Access Compliance Report Public Rights-of-Way (Pedestrian Signals)

Main Street: **IRVINE_AVE** Cross Street: **UNIVERSITY_DR** Location: **NW**

ADA ID: **SGRK211018112642** Signal Type: **One Push Button-Non APS** Overall Compliance: **No** Severity Scores: **BTN 1: 35** **BTN 2: N/A** **No BTN: N/A**

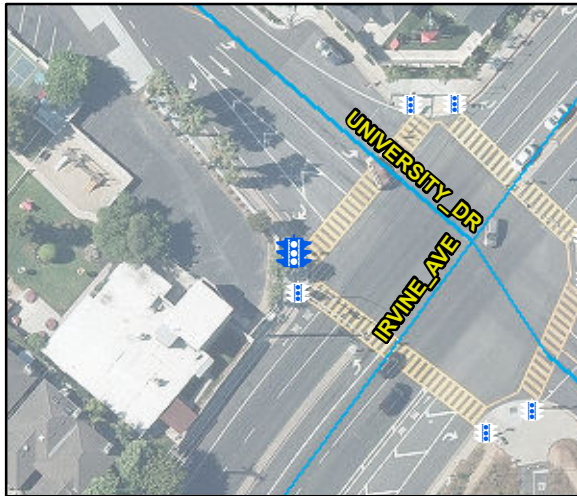
Surveyor Notes: Button 2 for Bike Lane

Possible Solutions: Replace Signal Push Button With APS Button. Remove and Replace Clear Space.
